Record of Executive Business and Chief Executive's Order

Reg. Reference: SD21B/0469 **Application Date:** 06-Sep-2021
Submission Type: Additional **Registration Date:** 17-Nov-2021
Information

Proposed Development: New front porch and canopy, single storey rear and
side extension, dormer window to rear roof, widening
vehicular access, 'Velux' window to the front, some
internal alterations and associated site works.

Location: 2, Aranleigh Gardens, Rathfarnham, Dublin 14

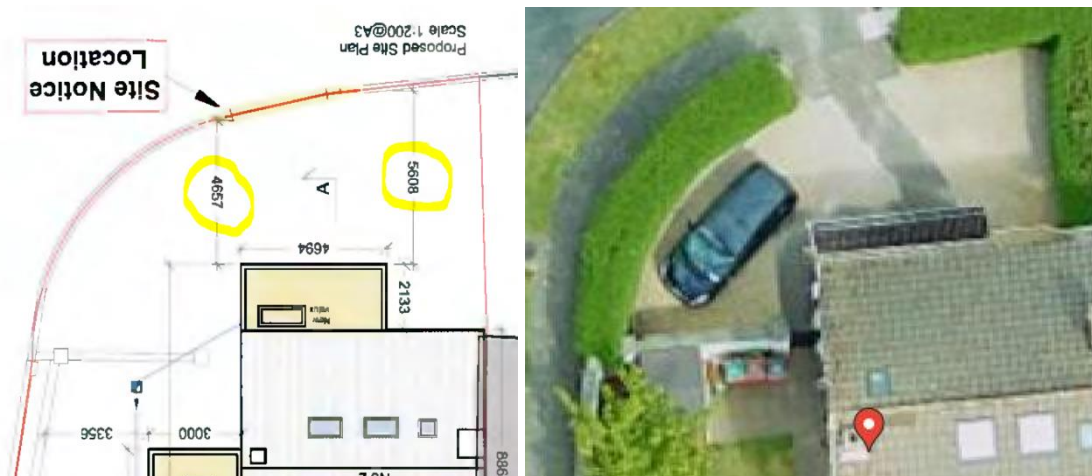
The application proposed to increase the width of the vehicular entrance from 3.174m to 3.5m. A report received from the Roads Department recommends **Additional Information** be requested regarding concerns relating to visibility splay sightlines, appropriate and safe vehicular access & egress from the site and the shortfall in driveway length requirements. The report then recommends **conditions** to be attached in the event of grant.

The drawing submitted does not clearly show the layout/dimensions for the existing or proposed vehicular entrance and these must be provided, and extents clearly shown.

Noted that there already exists a poor visibility splay on both sides for vehicles egressing due to the existence of a tall dense hedge.

Roads Dept seek min 6m from front of building line to front boundary wall. The dimensions proposed fall well short of this distance and raise concerns regarding vehicular access and

egress from the proposed development, and will require an AutoTRAK Swept Path analysis drawing to illustrate these movements can be carried out safely.

1. *The applicant shall submit a revised layout clearly showing:*
 - a. *Where the existing piers are located, and the dimension between.*
 - b. *The pier proposed to be removed, the new pier proposed location and the dimension between.*
 - c. *3no. distance measurements from corner of new porch to the boundary as it sweeps around.*
2. *AutoTRAK Swept Path analysis drawing showing the traffic movements required for a vehicle to safely access and egress the site.*

The above condition 1 is unenforceable. Notwithstanding the report from the Roads Department, it can be seen from the drawings submitted that the applicant proposed to increase the width of the vehicular entrance from 3.174m to 3.5m. From the drawings submitted the single storey front extension will project outwards from the main front building line by c.1.5m which is the same projection as the existing single storey front element. However, the proposed front extension will also have a canopy projecting out by a further 0.6m. In its current state the canopy will be supported by two block walls (piers) either side with each pier projecting out from the extension by 0.6m creating an architectural alcove feature. This will create more obstacles for a vehicle to have to navigate safe access and egress. It is therefore considered appropriate to request the **additional information** recommended by the Roads Department.
